CITY PLAN COMMISSION STAFF REPORT

Project Name
4646 Bellevue Development Plan and Rezoning

Docket #3

Request

Rezoning and Development: Site Plan

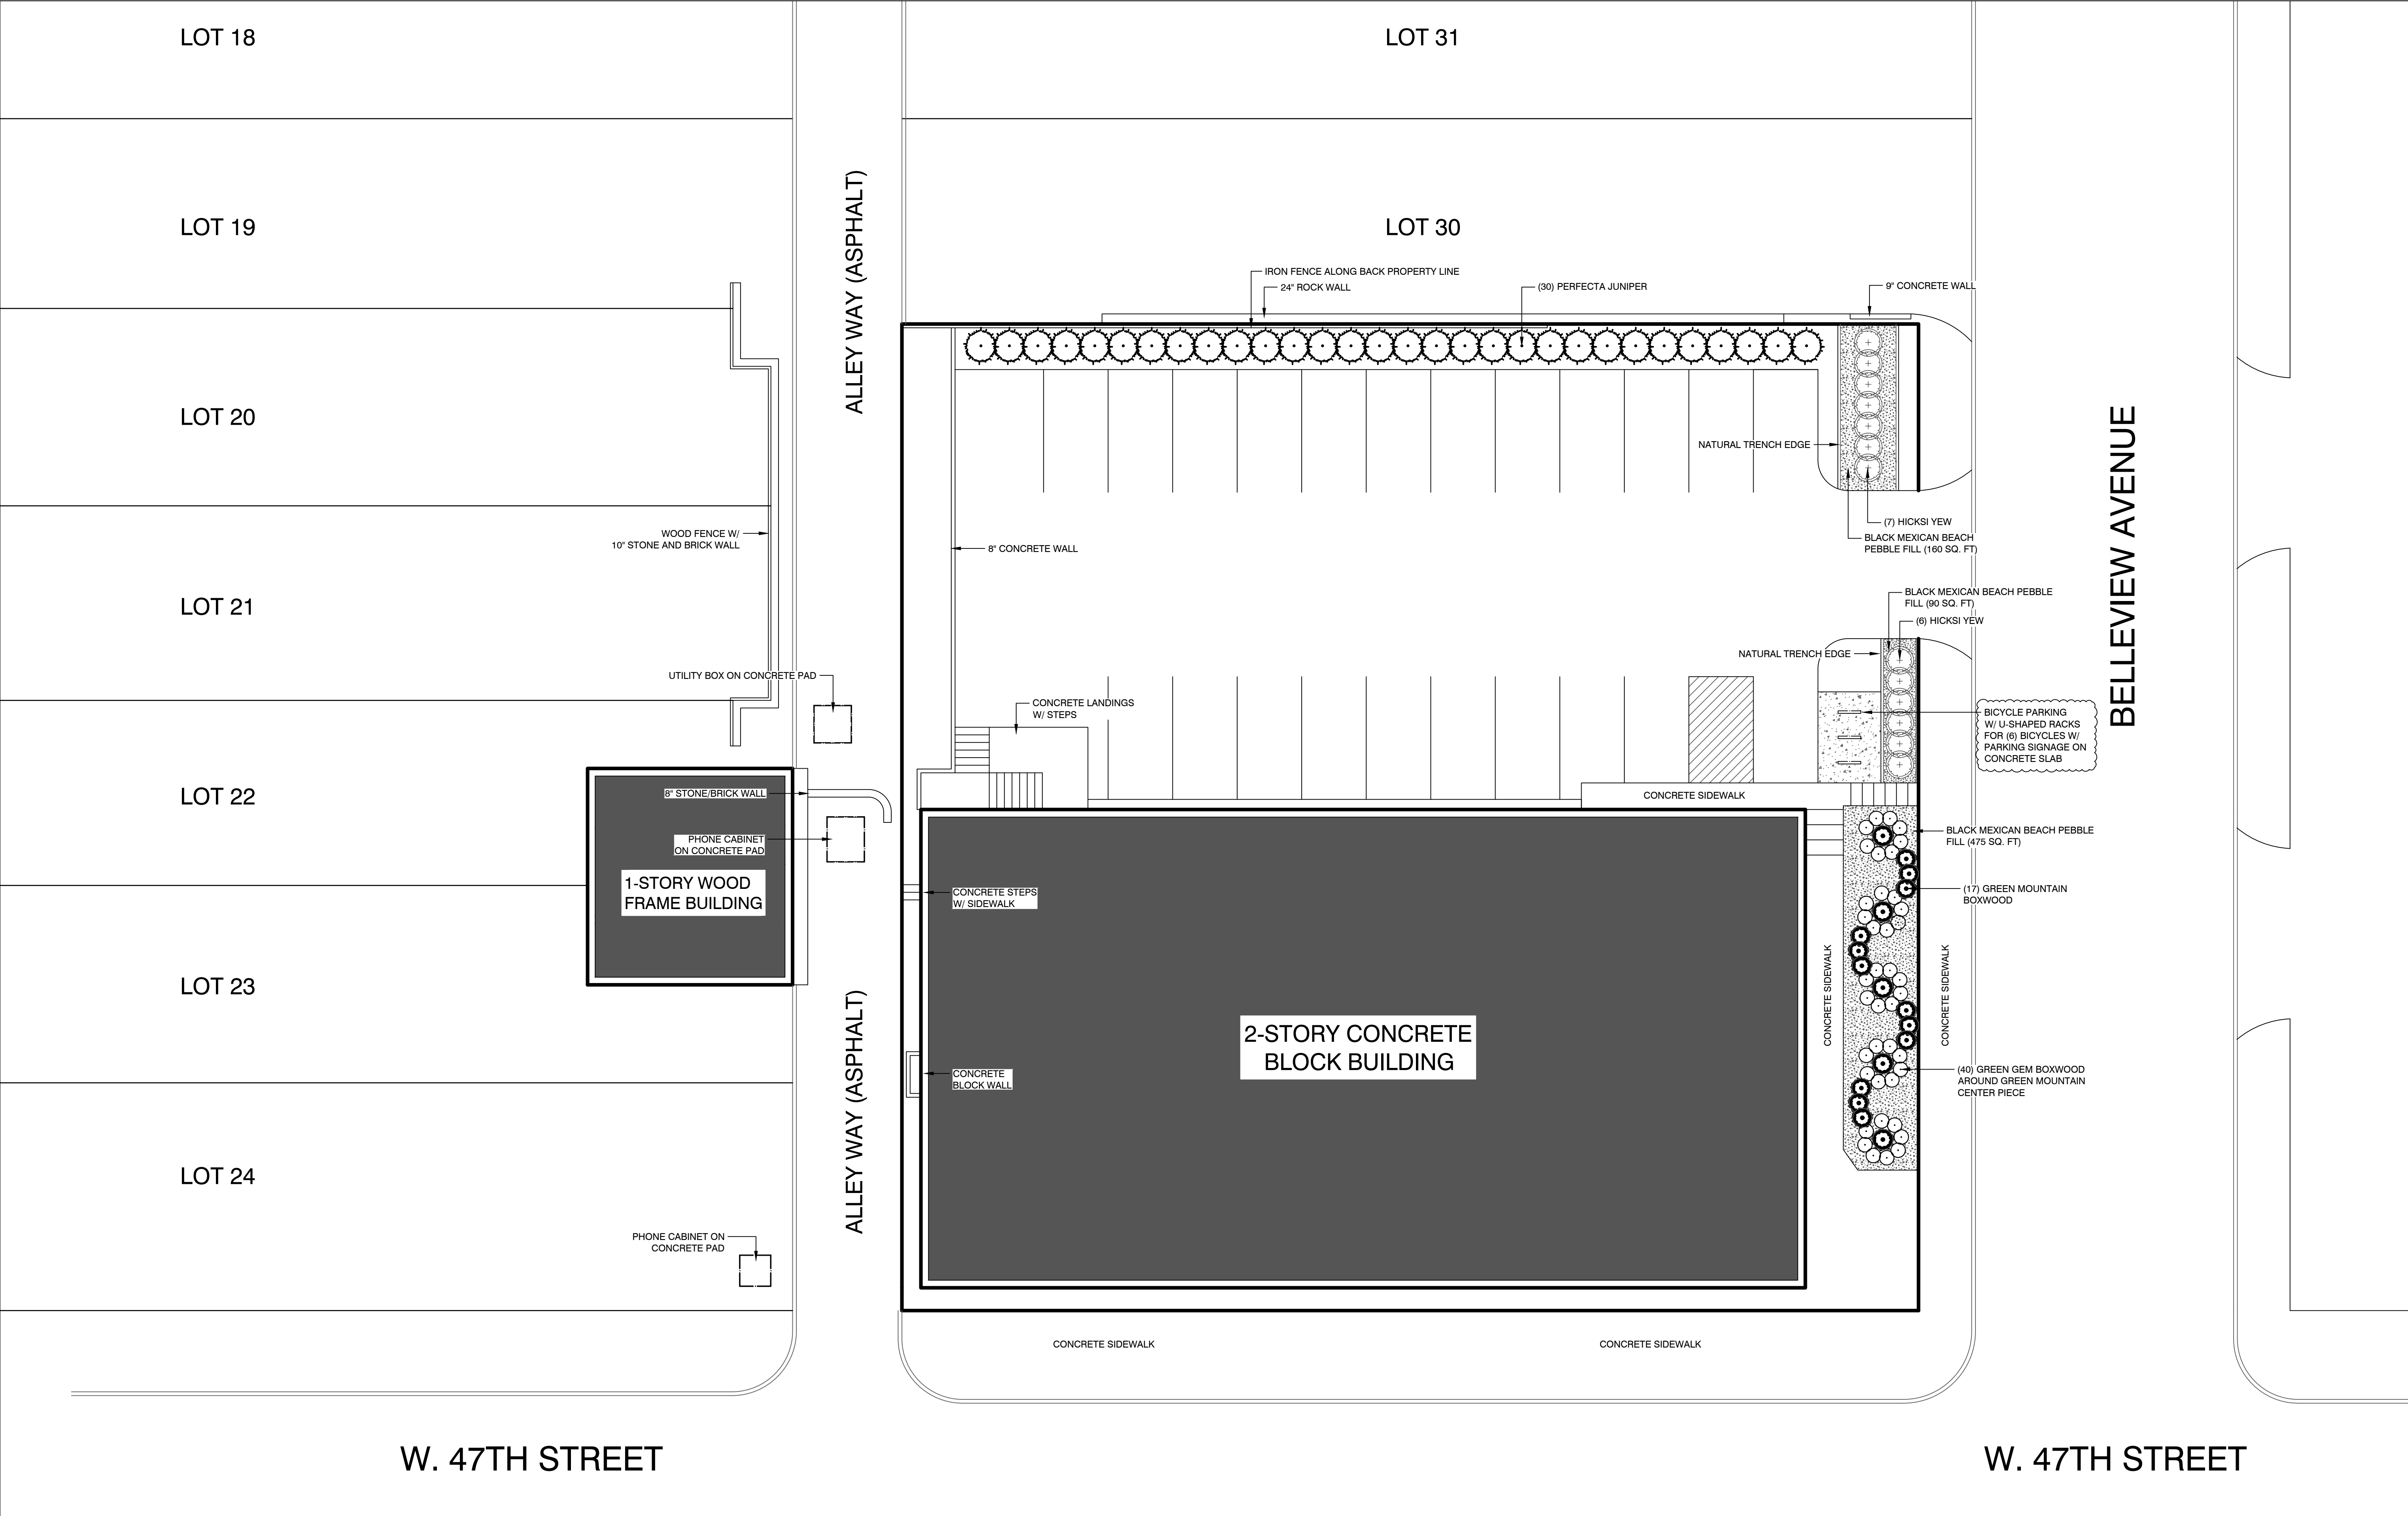
Long Range Planning Division stated, "As a medium-sized event space, the proposed use does not deviate greatly from the former church in terms of land use. The additional story matches nearby form and massing. Given the potential for high speeds on Belleview, the applicant should discuss if changes should be made to access off that avenue. While this project repurposes, an existing building supported

with infrastructure, the landscaping relies on non-native plants. The KC Spirit Playbook recommends native plants that do not require significant maintenance or watering."- Luke Ranker
